RE: 108-ZN-1984#2 - Desert Cove Self Storage – Scottsdale; Comment Responses

Larson Engineering, Inc. (LEI) is pleased to present the comment responses below in regards to the City of Scottsdale Review comments dated 8/16/2022 for **Desert Cove Self Storage Facility** development in Scottsdale, Arizona.

City of Scottsdale Comment Responses
Desert Cove Self Storage Facility
Scottsdale, AZ
September 1st, 2022

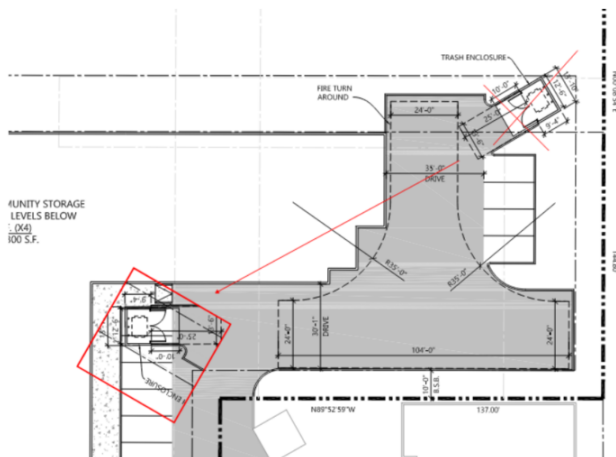
2. Please provide a revised Drainage Report and Grading and Drainage Plan with the resubmittal, addressing the following General Underground Storage Requirements:
 - a. Level of detail required for the underground storage system design is 75% in the preliminary drainage report.
 - Please see the revised Drainage Report reflecting updated information and revised calculations
 - b. Drainage easement is required over underground storage system
 - See the attached revised Grading and Drainage plan reflecting the added easements for both tank systems.
 - c. Service life of 75 years per MAG standard detail 2554

- See the revised service life updated information within the Drainage Report, and on the revised Grading and Drainage Plan
- d. Underground retention system must drain by gravity.
